Wisconsin Department of Transportation

Proposal #05: 2704-09-70
Braun Road
IH 94 EFR to CTH H
Local Street
Racine County

Letting of June 12, 2018

This is Addendum No. 01, which provides for the following:

Addendum No. 01
 ID 2704-09-70
 Revised Sheet 24
 May 31, 2018

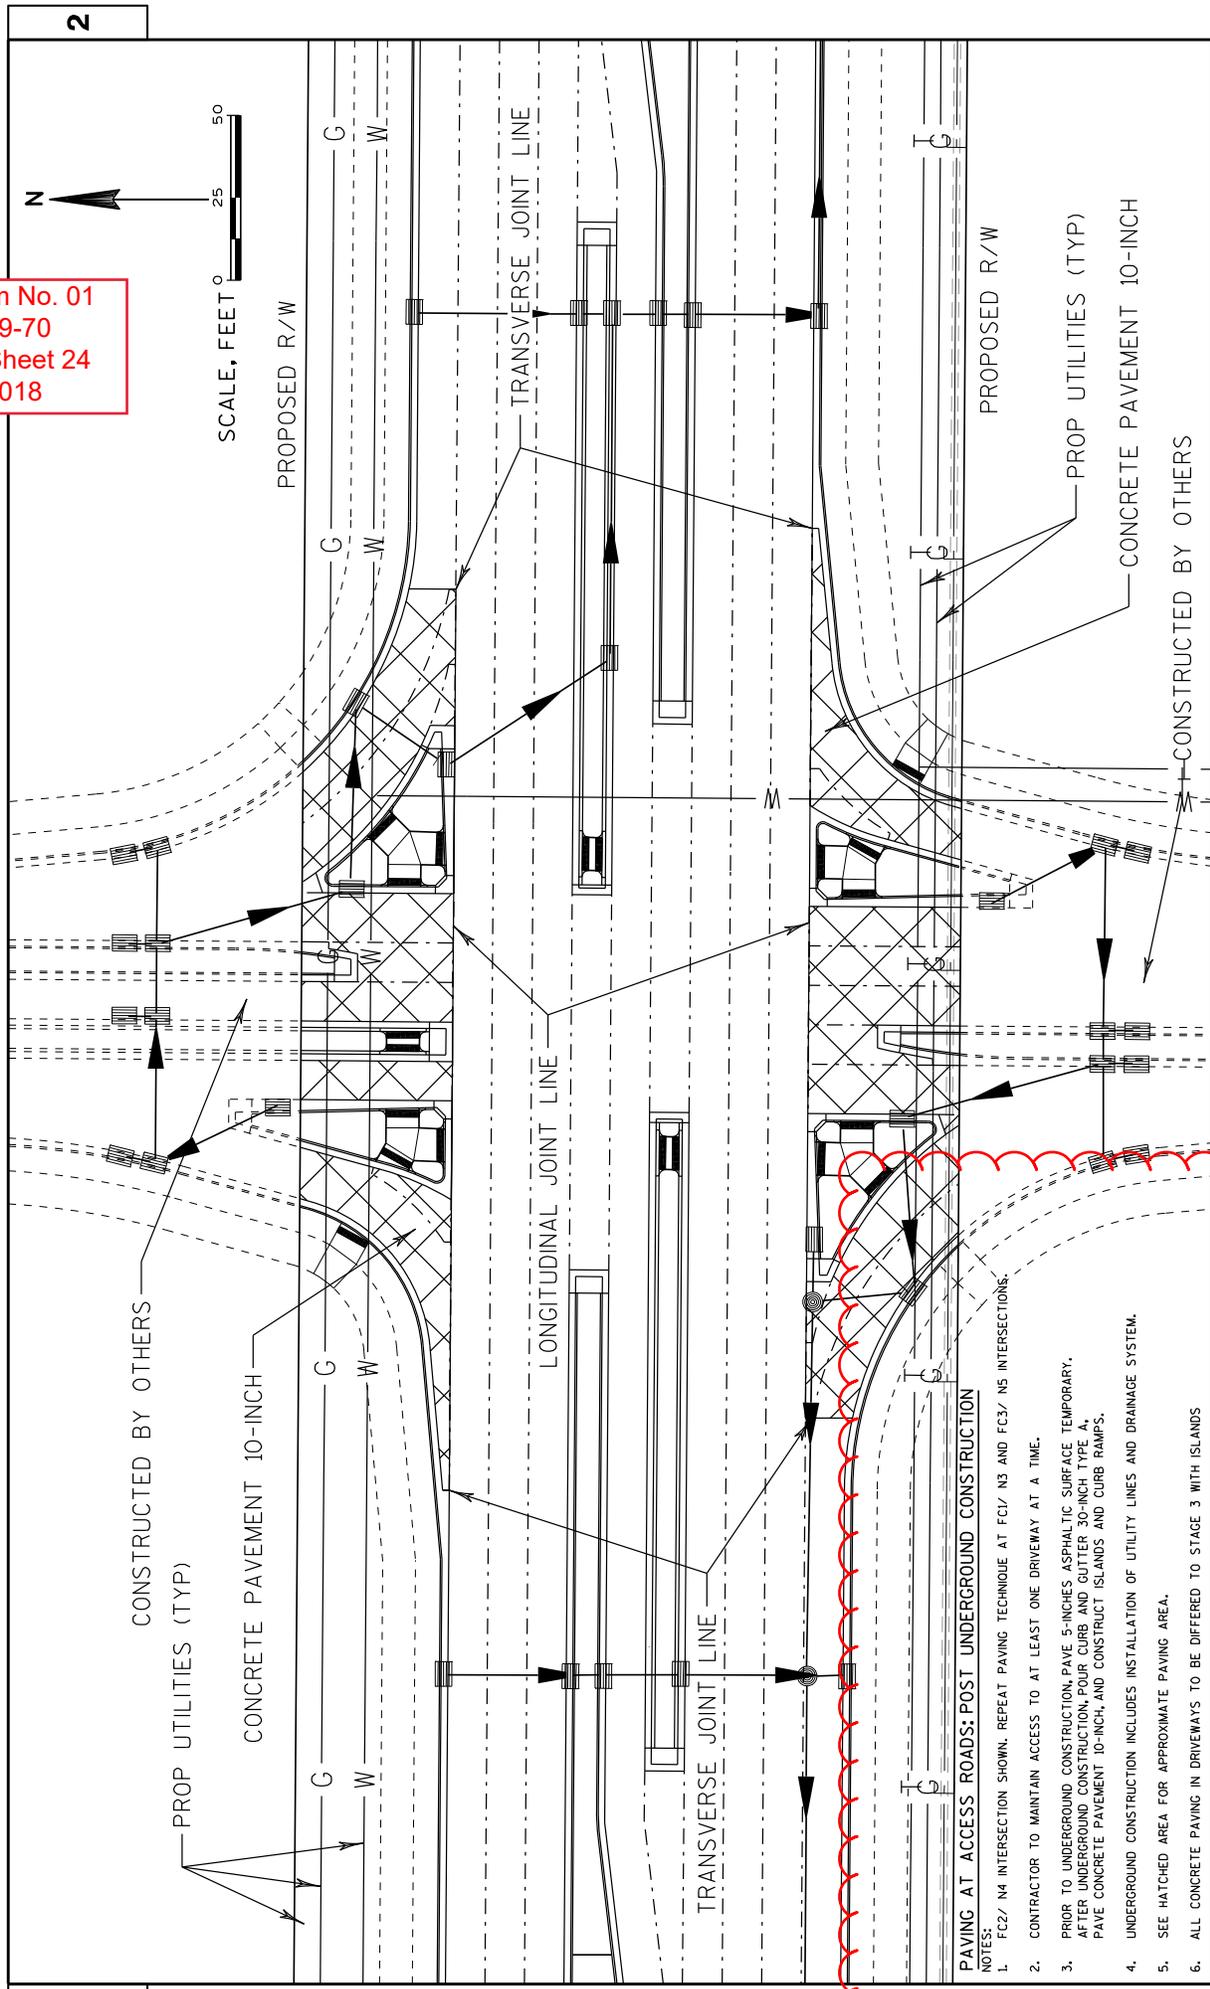
Revised Plan Sheets	
Plan Sheet	Plan Sheet Title (brief description of changes to sheet)
23	Construction Details (revised notes section)
24	Construction Details (revised notes section)
25	Construction Details (Topsoil removal in fill)
26	Construction Details (revised callouts)
27	Construction Details (revised callouts)
113-116	Storm Sewer (deleted pipe/revised callouts)
131	Storm Sewer (revised callouts)
132	Storm Sewer (revised callouts)
139-141	Storm Sewer (revised callouts)
181	Traffic Signal Project Overview (added signal numbers)
182	Traffic Signal Plan (revised detection)
183	Traffic Signal Plan (added traffic signal number)
184	Sequence of Operations (revised detection)
186	Cable Routing (revised detection)
187	Communication Project Overview (added signal numbers)
188	Communication Plan (added signal number, revised communication vault)
205	Typical Sections – Braun Road Staging (deleted West side tie-in)

- PAVING AT ACCESS ROADS: POST UNDERGROUND CONSTRUCTION**
- NOTES:
1. FC2/ N4 INTERSECTION SHOWN. REPEAT PAVING TECHNIQUE AT FC1/ N3 AND FC3/ N5 INTERSECTIONS.
 2. CONTRACTOR TO MAINTAIN ACCESS TO AT LEAST ONE DRIVEWAY AT A TIME.
 3. PRIOR TO UNDERGROUND CONSTRUCTION, PAVE 5-INCHES ASPHALTIC SURFACE TEMPORARY. AFTER UNDERGROUND CONSTRUCTION, POUR CURB AND GUTTER 30-INCH TYPE A, PAVE CONCRETE PAVEMENT 10-INCH, AND CONSTRUCT ISLANDS AND CURB RAMPS.
 4. UNDERGROUND CONSTRUCTION INCLUDES INSTALLATION OF UTILITY LINES AND DRAINAGE SYSTEM.
 5. SEE HATCHED AREA FOR APPROXIMATE PAVING AREA.
 6. ALL CONCRETE PAVING IN DRIVEWAYS TO BE DEFERRED TO STAGE 3 WITH ISLANDS

Addendum No. 01
ID 2704-09-70
Added Sheet 25A
May 31, 2018

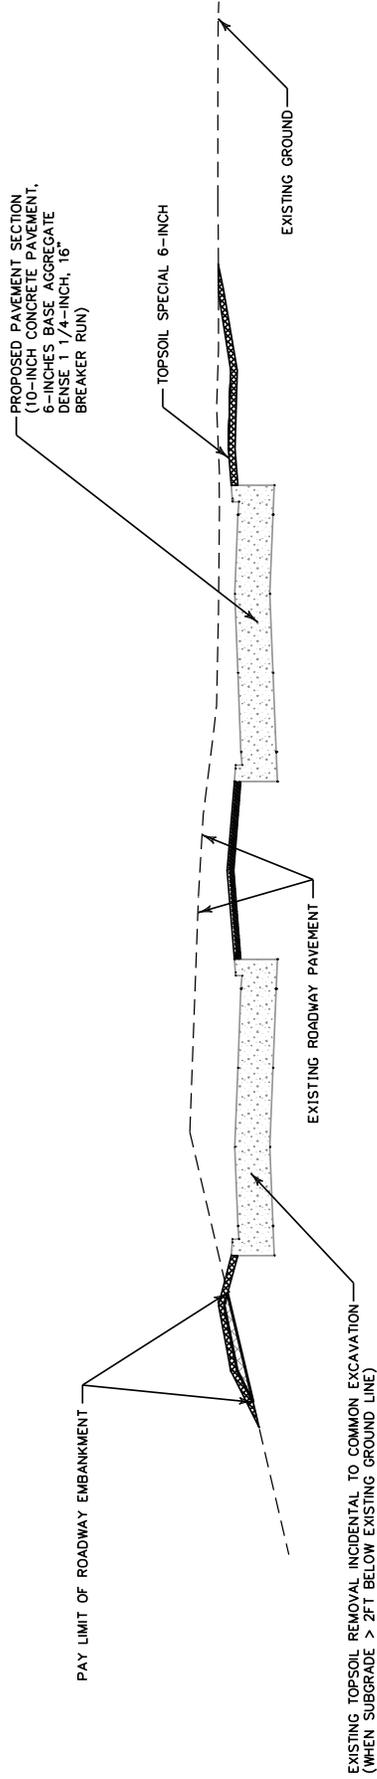
Added Plan Sheets	
Plan Sheet	Plan Sheet Title (brief description of why sheet was added)
25A	Construction Details (Topsoil removal, subgrade in partial cut)
25B	Construction Details (Topsoil removal, subgrade in fill)
27A	Construction Details (added real estate status detail)
27B	Haul Routes June 1 – June 17, 2018 (Added Construction Detail)
27C	Haul Routes June 18 – July 31, 2018 (Added Construction Detail)
27D	Haul Routes August 1 – August 30, 2018 (Added Construction Detail)
27E	Haul Routes September – November, 2018
27F	Haul Routes Winter 2018 – Spring 2019
67A	FTMS Plans – Overview (FTMS/ITS now included in the plans)
67B– 67O	ITS Plans (FTMS/ITS now included in the plans)
240A	Traffic Control – Stage 2A (extended limits shown)
249A	Traffic Control – Stage 2B (extended limits shown)
397A	Miscellaneous Quantities (FTMS/ITS now included in the plans)

Addendum No. 01
 ID 2704-09-70
 Revised Sheet 518
 May 31, 2018

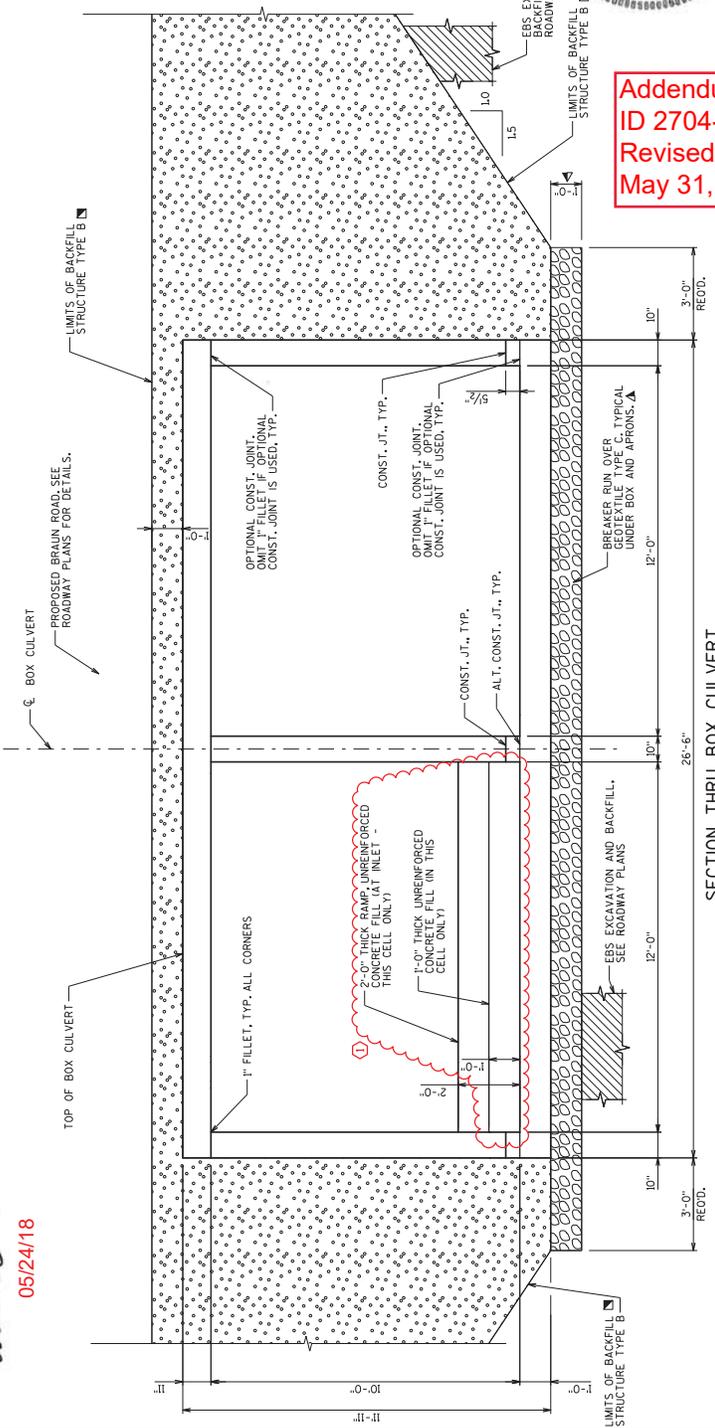
362	Miscellaneous Quantities (revised storm sewer quantities)
364- 368	Miscellaneous Quantities (revised storm sewer quantities)
373	Miscellaneous Quantities (revised storm sewer quantities)
379	Miscellaneous Quantities (revised storm sewer quantities)
380	Miscellaneous Quantities (revised storm sewer quantities)
382- 384	Miscellaneous Quantities (revised storm sewer quantities)
394	Miscellaneous Quantities (revised detection items)
395	Miscellaneous Quantities (removed communication vault)
518- 523	Structures (dry cell revision)
525- 530	Structures (dry cell revision)
535- 539	Earthwork (Deleted West tie-in)

* 190 CY OF TOTAL IS FOR UNREINFORCED CONCRETE FILL IN WEST CELL AND AT APRONS. SEE "UNREINFORCED CONCRETE FILL AND RIPRAP LIMITS" SHEET FOR DETAILS.
